LUMINARY Memo # 118

To: Distribution
From: D. Eyles
Date: 27 October 1969
Subject: Landing Changes Put Into LUMINARY 1C

Four changes that affect the landing were made for LUMINARY 1C:

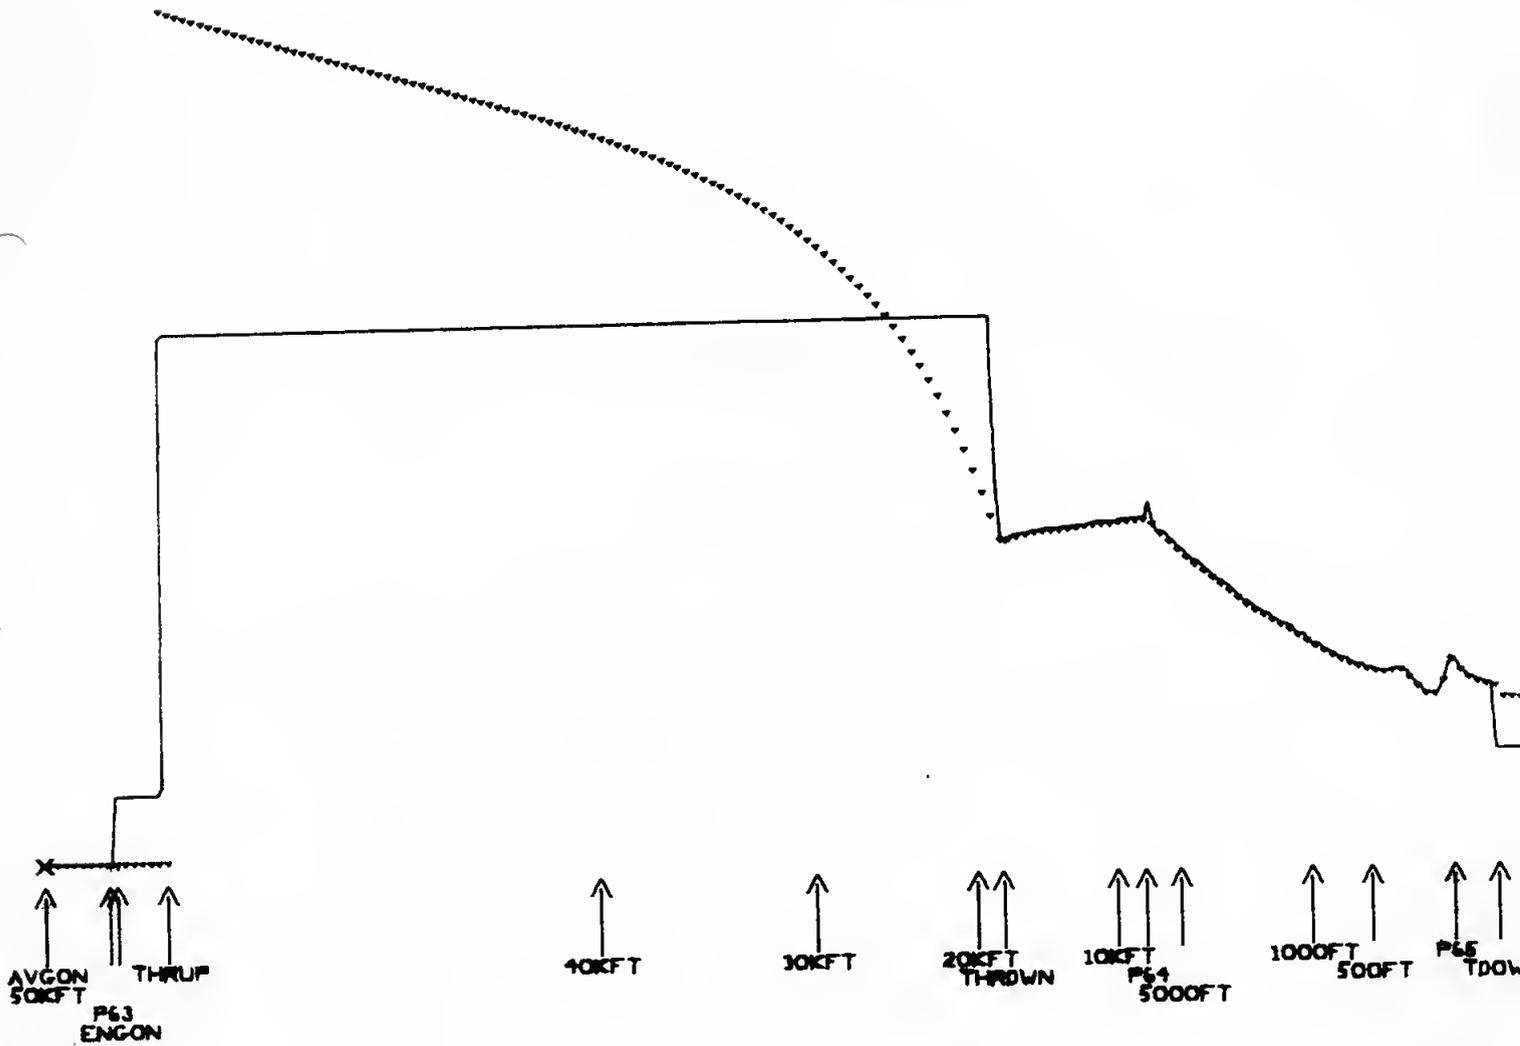
THRCMD is the percent throttle desired by the LGC, based on the DPS rated thrust of 10500 pounds. Half-throttle would look like this: +00050. Thrust and thrust desired for a nominal landing look like this (thrust desired is the dotted line):
